**B2GOLD Back River CORP.**

## MEMO

<b>From</b>	Merle Keefe
<b>To</b>	Richard Dwyer
<b>Ref.</b>	2AM-BRP1831
<b>Date</b>	14 May 2024
<b>Subject</b>	Llama and Umwelt Dewatering Plan – Responses to Review Comments

Aquatic Effects Monitoring Program sampling locations have now been depicted in an update to Figure 3 of the Dewatering Plan, provided below.

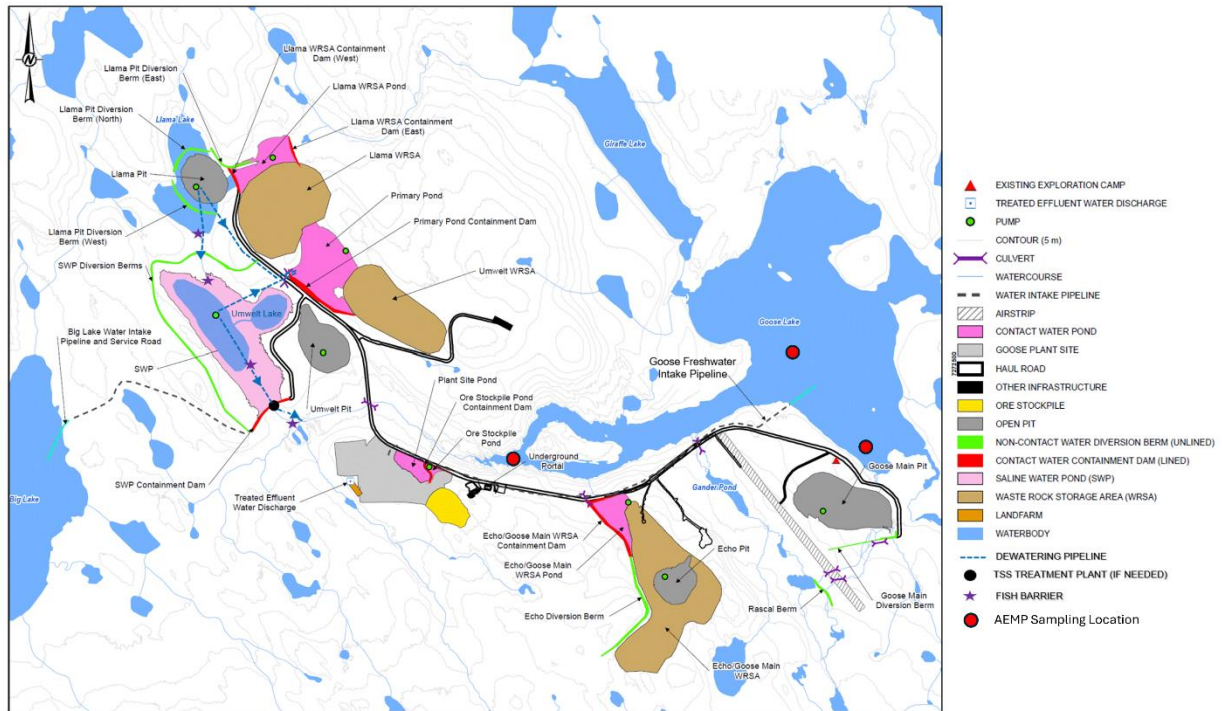
Several monitoring locations are discussed in Section 6.1 of the Dewatering Plan, including, Llama Lake, Umwelt Lake, and dewatering discharge at point of release. The Dewatering Plan also refers to potential samples from the shore of Llama and Umwelt Lakes, as well as water quality in Goose Lake as part of the Aquatic Effects Monitoring Program (AEMP). ECCC notes that these sample locations are not depicted on the figures provided.

ECCC recommends that the Proponent provide a figure that clearly outlines the monitoring locations associated with the dewatering program.

B2Gold Nunavut apologizes for inadvertently omitting responses to this comment. In the 'Updated Dewatering Plan' (v1.1) submitted with the previous comment responses, B2Gold Nunavut clarified the sampling programs and locations in Section 8.1 of the Plan.

Sampling locations include those prescribed by the Water Licence:

- BRP-01 - Goose Lake Discharge; sampling of the dewatering discharge at the point of release to the drainages upstream of Goose Lake
- BRP-02 - Llama Lake; sampling of raw water when treatment is required, and
- BRP-06 - Umwelt Lake; sampling of raw water when treatment is required.

The location of BRP-01 will be determined in the field based on the discharge point used and would be reflective of the water being released. BRP-02 and BRP-06 samples would be collected from a sampling port in the water uptake line for each of these two lakes during pumping, as this would be the most representative of water being pumped. If water is not being actively pumped (such as during a pause to allow wind, or rain generated TSS to settle, or if water is being allowed to passively overflow from Umwelt Lake), shoreline or outflow samples may be collected at the most accessible location to determine raw water quality of Llama of Umwelt lakes.
